**ADDENDUM NO. 4**  
**Penguin Life Support System Upgrade**  
**REQUEST FOR BIDS #11-1717**  
**September 3, 2010**

THE FOLLOWING ARE CHANGES TO THE CONTRACT DOCUMENTS

SCALE: 1"=1'-0"	TITLE: ADD ALTERNATE 2-STAIR SECTION	SHEET NO.: RS07
JOB NO.: 309265	PROJECT: PENGUIN LIFE SUPPORT SYSTEM OREGON ZOO	REFERENCE SHEET NO.: 1/S5.3A
DATE: 09/02/2010

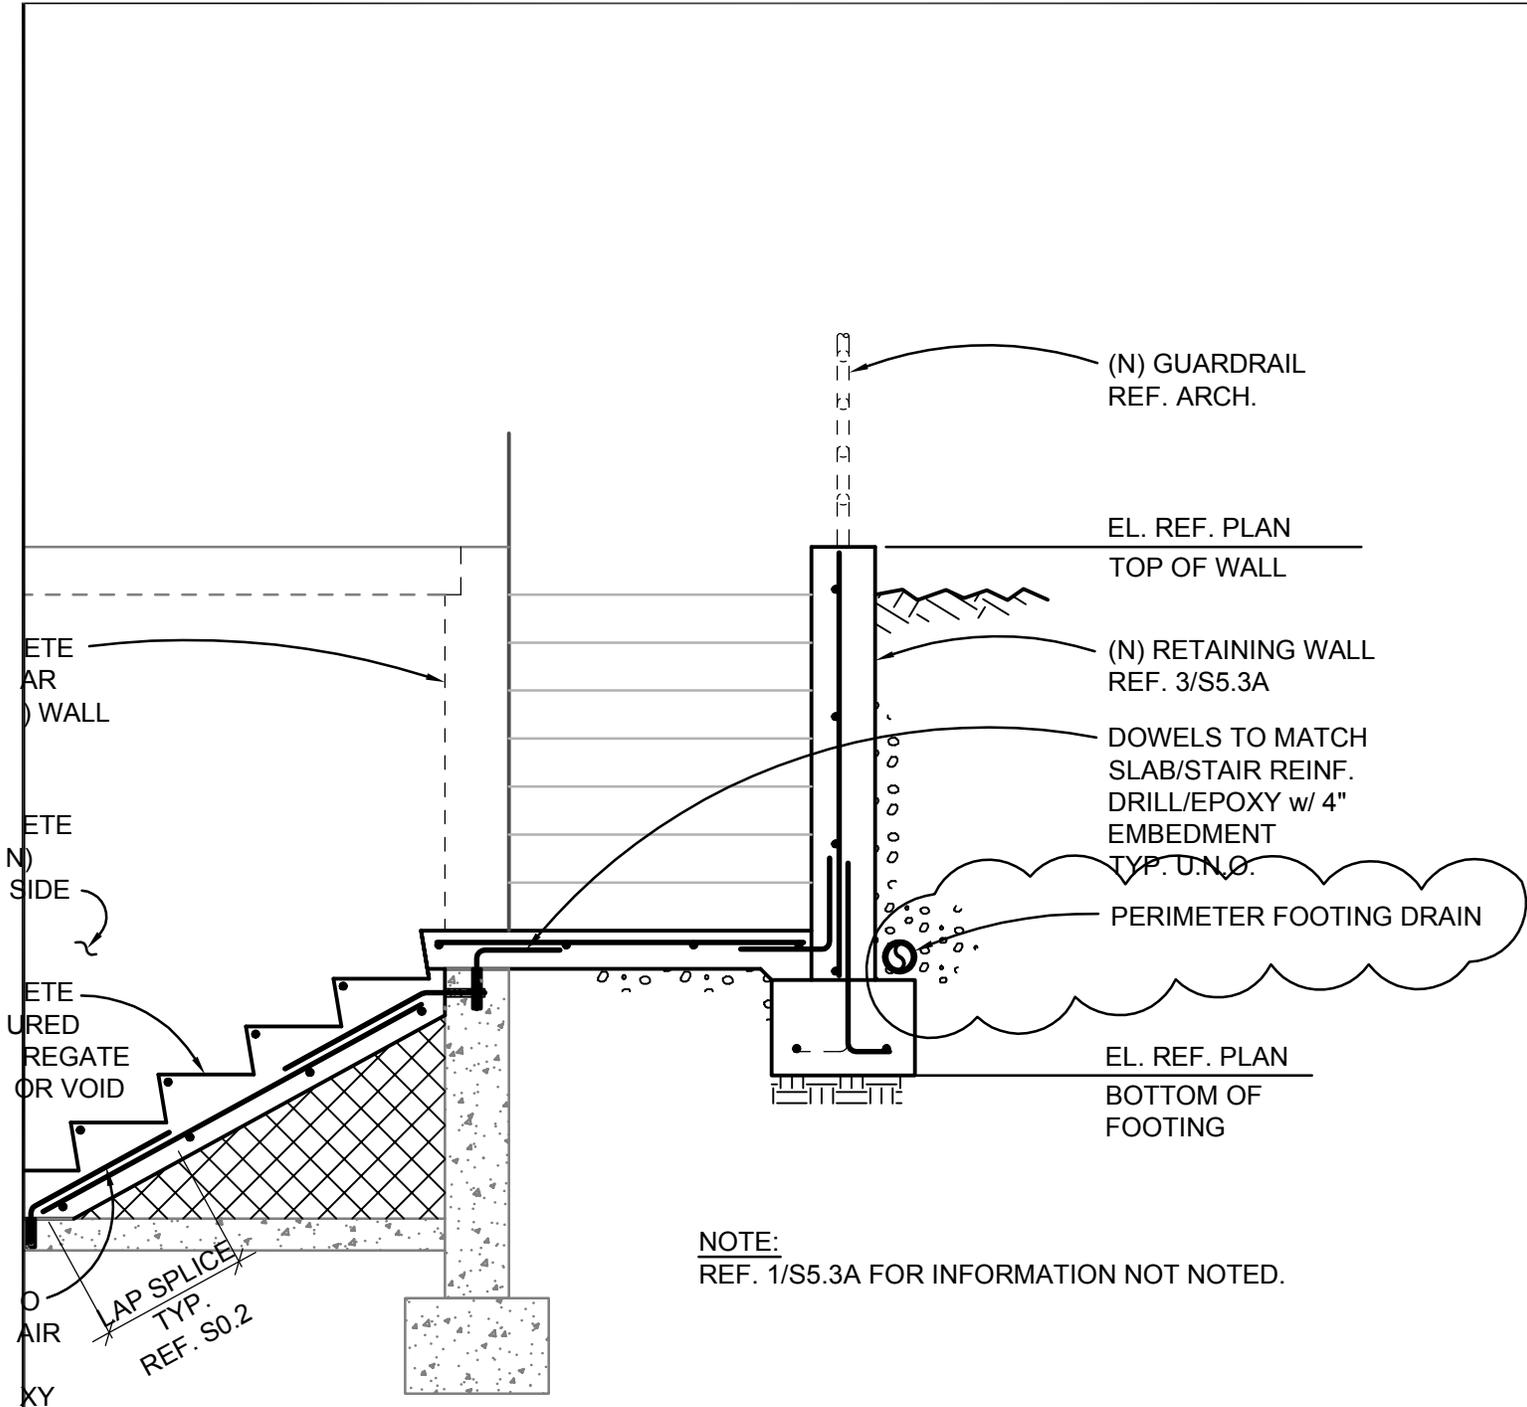
J. DRAWING RS07 NAME: S5.3A ADD ALTERNATE 2 - STAIR DETAILS, DETAIL 1, REVISION MADE:

1. As shown on drawing.

**NOTE:**  
 DRILL/EPOXY #4 TRANSVERSE BARS  
 INTO (N) TANK WALL BEYOND  
 w/ 4" MIN. EMBEDMENT, REF. 4/S5.1 SIM.

SCALE: NTS	TITLE: ADDENDUM#4-ELECTRICAL_SITE_PLAN	SHEET NO.: RE 02
JOB NO.: 309265	PROJECT: PENGUIN LIFE SUPPORT SYSTEM UPGRADE OREGON ZOO	REFERENCE SHEET NO.: E1.0
DATE: 09/02/2010

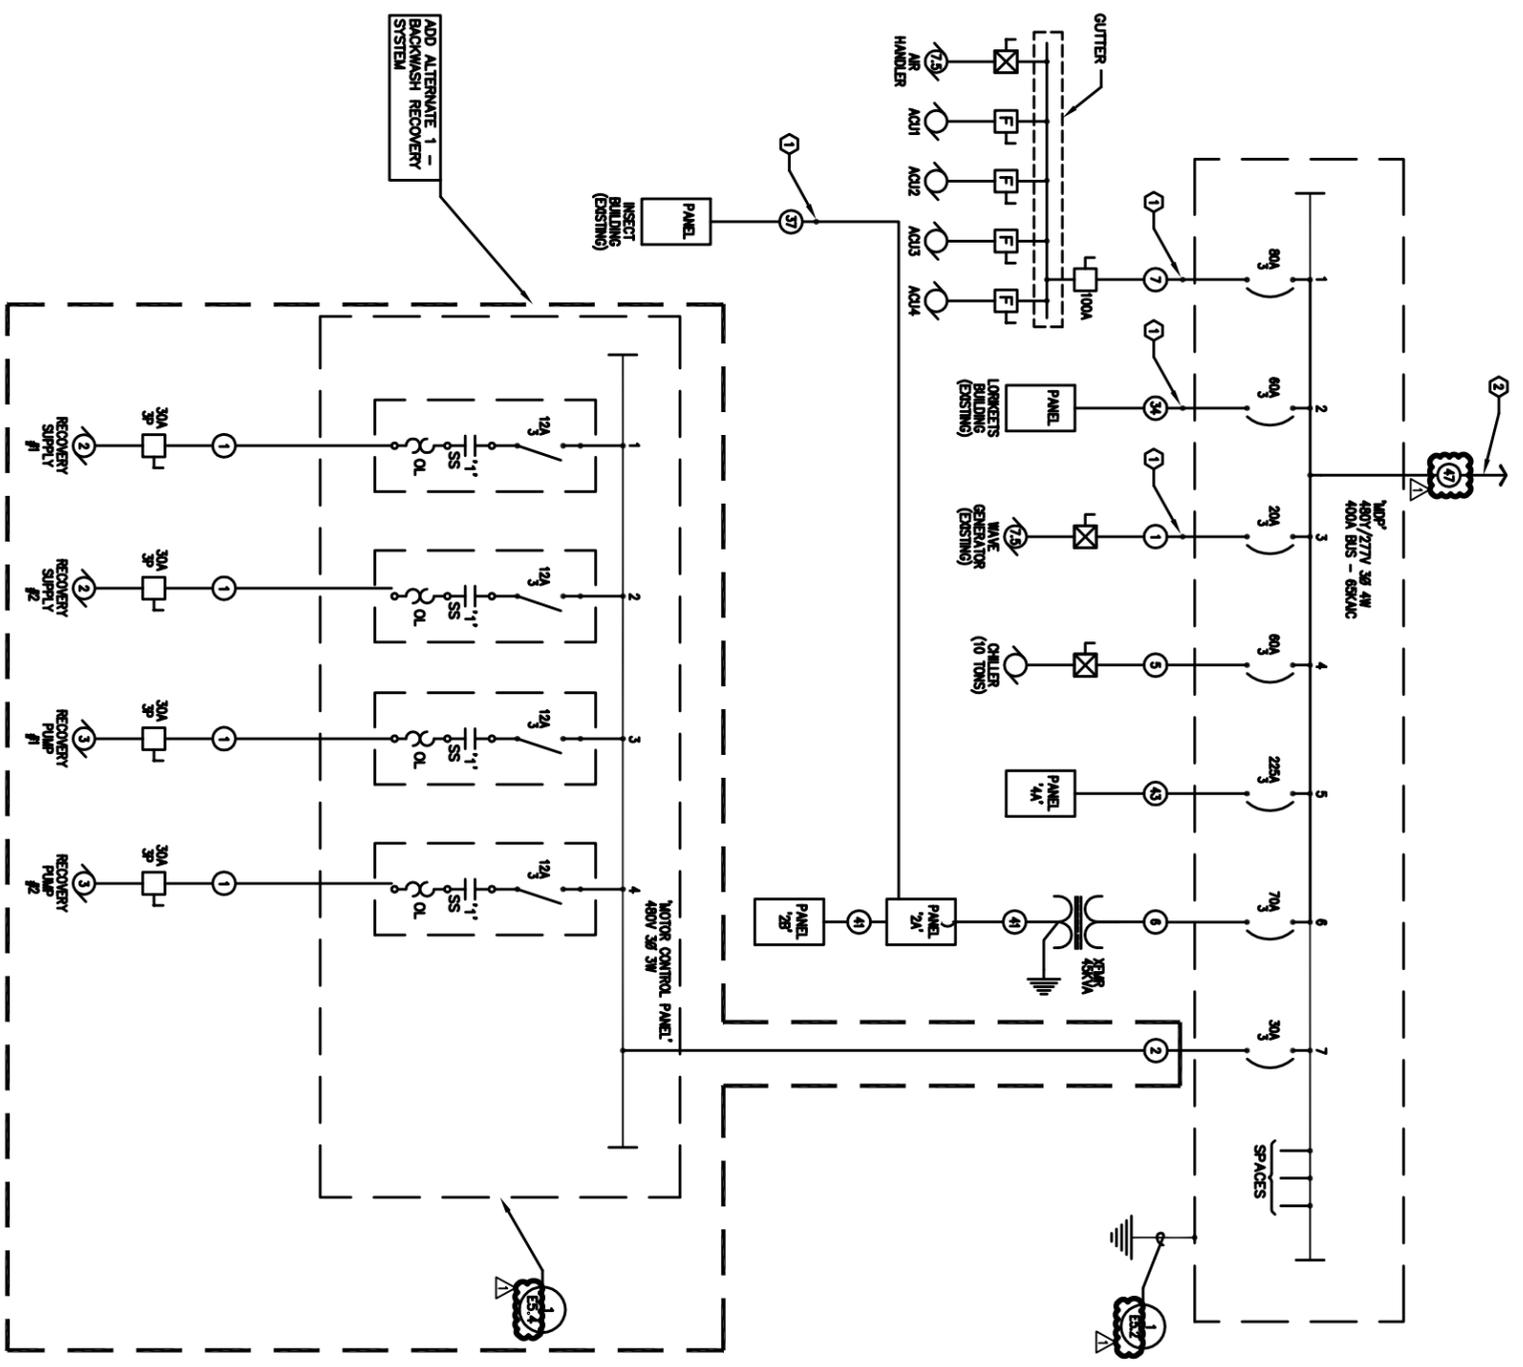
M. DRAWING RE02 NAME: E1.0 ELECTRICAL SITE PLAN, NOTES, REVISION MADE:

1. REVISE note 1 as shown on drawing

1. INTERCEPT EXISTING ELECTRICAL FEEDER TO PENGUIN BUILDING AND REROUTE TO NEW 400A DISCONNECT. PROVIDE NEW CONDUIT AND FITTINGS AS REQUIRED. PROVIDE NEW CONDUCTORS BACK TO NEW 400A CIRCUIT BREAKER IN EMERGENCY GENERATOR DISTRIBUTION PANEL VIA EXISTING CONDUIT AND VAULTS. SEE ONE-LINE DIAGRAM.

SHEET NO.: RE 03

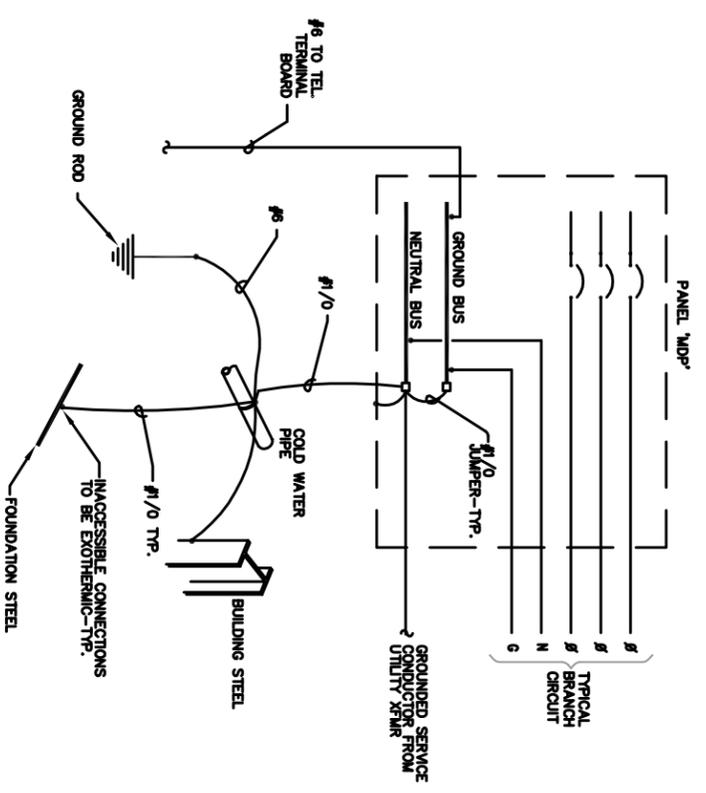
N. DRAWING RE03 NAME: E5.1 ELECTRICAL ONE-LINE DIAGRAM, REVISION MADE:

1. REVISE main feeder type feeder type from '17' to '47' to clarify that a neutral conductor is required for the main service to the penguin building.
2. REVISE detail references as shown on drawing.

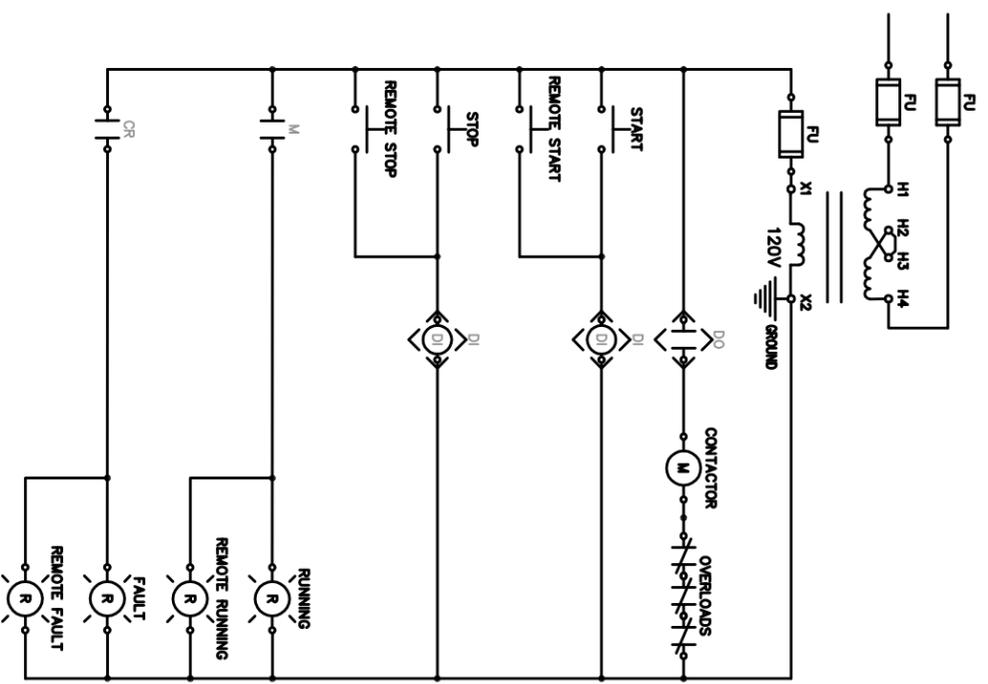
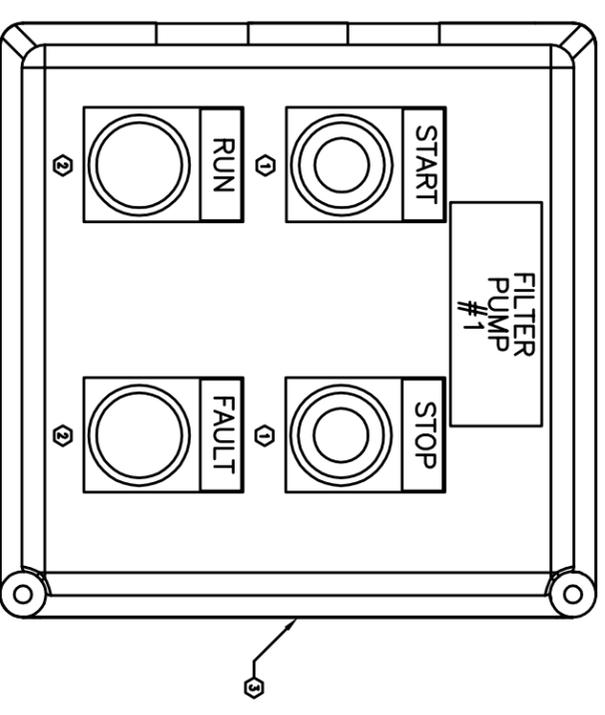
O. DRAWING RE04 NAME: C5.2 ELECTRICAL DETAILS, REVISION MADE

1. REVISE detail references as shown on drawing.
